Re: Turkey Point Units 3 and 4
Docket Nos. 50-250 and 50-251
Response to NRC Reactor Systems Branch Request for Additional Information
Regarding Extended Power Uprate License Amendment Request No. 205

Turkey Point Units 3 and 4

RESPONSE TO NRC REACTOR SYSTEMS BRANCH REQUEST FOR
ADDITIONAL INFORMATION REGARDING EXTENDED POWER UPRATE
LICENSE AMENDMENT REQUEST NO. 205

Figure SRXB-1.3.21-1a

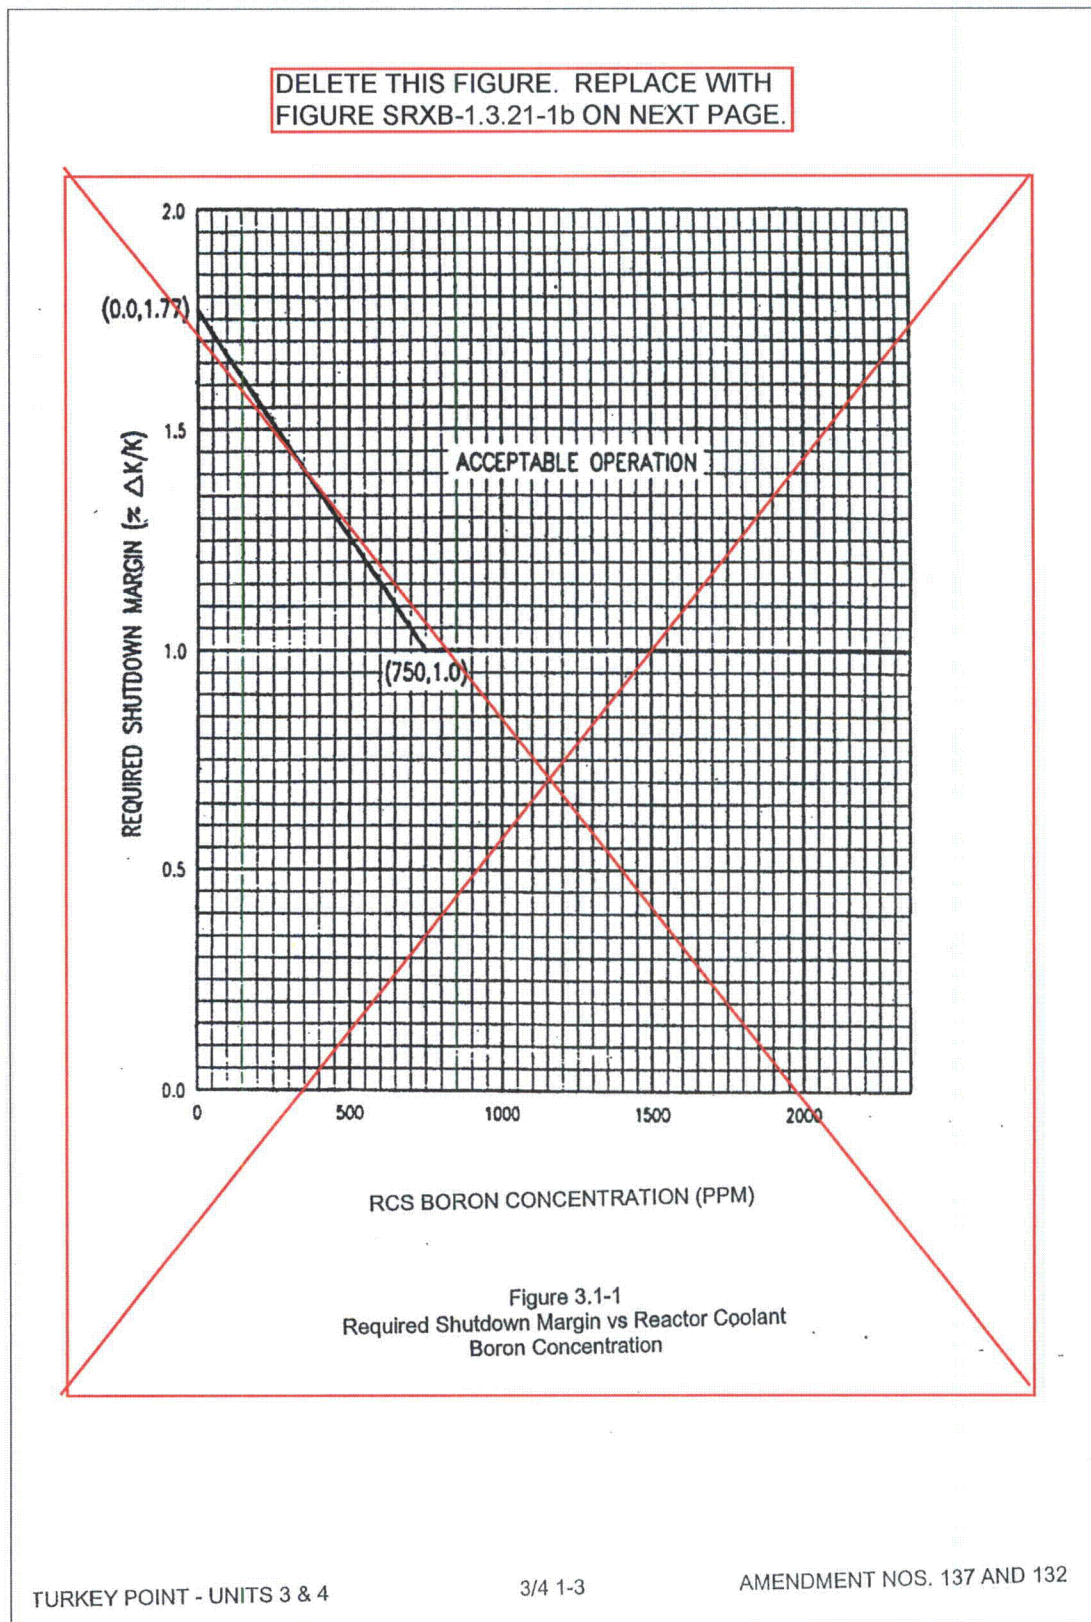
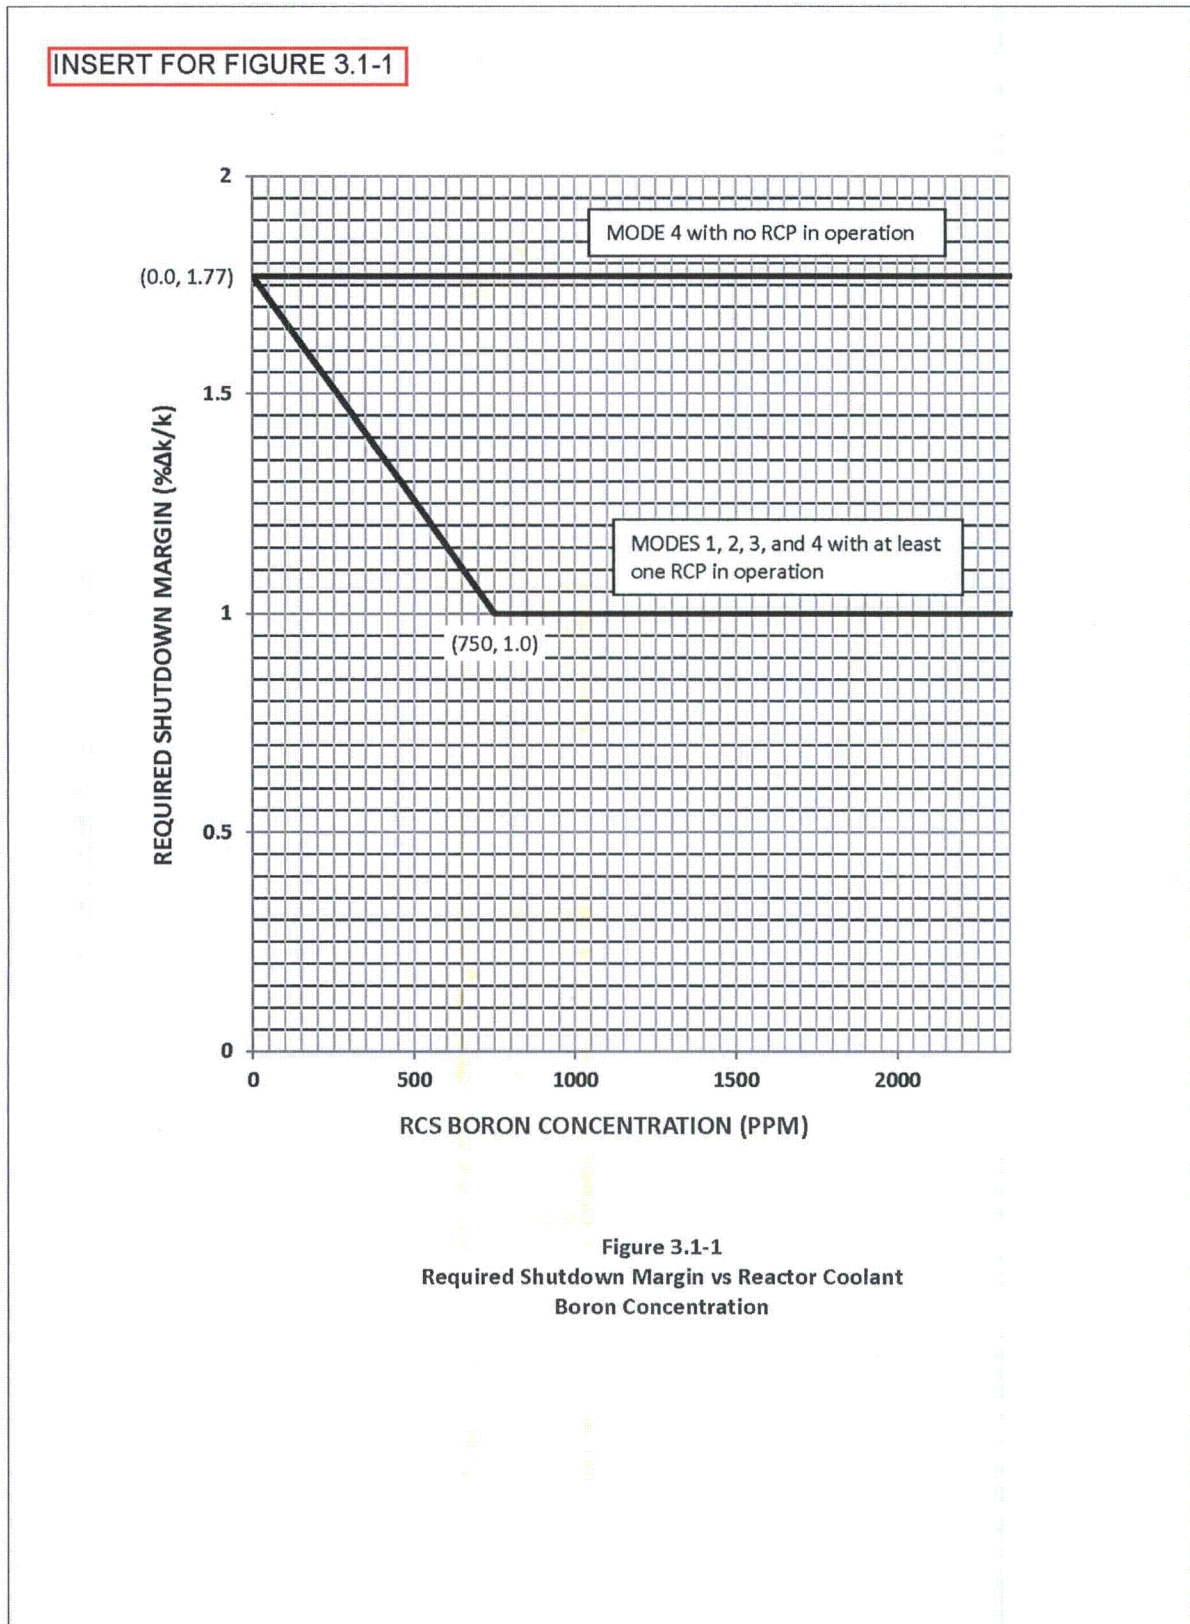
Figure 3.1-1, “Required Shutdown Margin vs Reactor Coolant Boron Concentration,” is revised as shown in Figures SRXB-1.3.21-1a and SRXB-1.3.21-1b to provide a separate curve representing the minimum allowable shutdown margin in Mode 4 when no reactor coolant pumps are operating.

Basis for the Change: An increase in the minimum allowable shutdown margin for Mode 4 without reactor coolant pumps operating is necessary to assure adequate operator response time is available to identify and terminate an inadvertent dilution event prior to loss of all shutdown margin.
